MODIFICATION ON TD40+OPS+OPA SYSTEM(6 0-10V DAC, 6 0-10V ADC, 3 4-20 MA)
* TD40 INSTALL LTC1446 REPLACING ULN2003 IN U18 AND U19
* TD40 INSTALL 250 OHM LANDING RESISTORS FOR 3 CH. 4-20 MA INPUTS
* 2 OPS MODIFIED FOR 6 CH. OF 0-4V IN AND 0-10V OUTPUTS
* OPA, NO ADC, RP1=100K, RP2=200K, R2=1K, R3=5K, 0-10V IN AND 5-0V OUT

Title		
TD40 MODIFICATION for 6 DAC outputs		
Size Document Number		REV
B	TD40-DAC.SCH	1
Date: September 30, 2003		Sheet 1 of 1

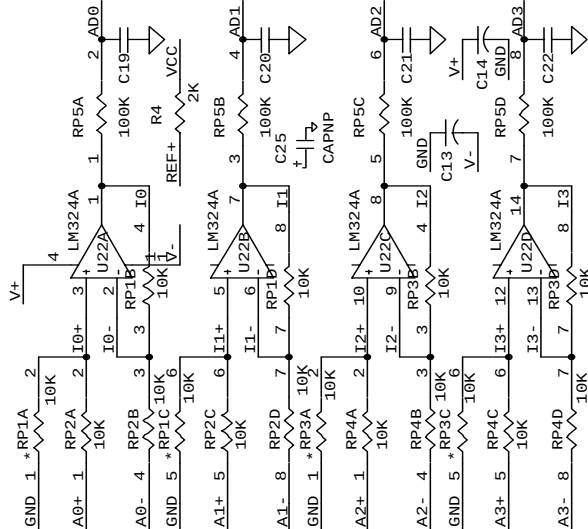
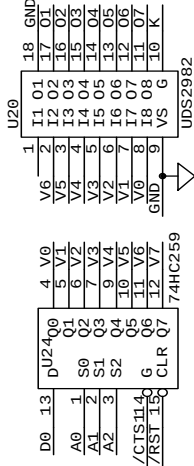
250 OHM LANDING RESISTORS FOR 4-20 MA INPUTS

OPA analog out on H3
5X2 Cable connects OPA H3 to TD40 H6
FORCE H3,7=AD5=GND

THIS H3 IS ON OPA

THIS H6 IS ON TD40

DO NOT install H6.9

DO NOT install H56
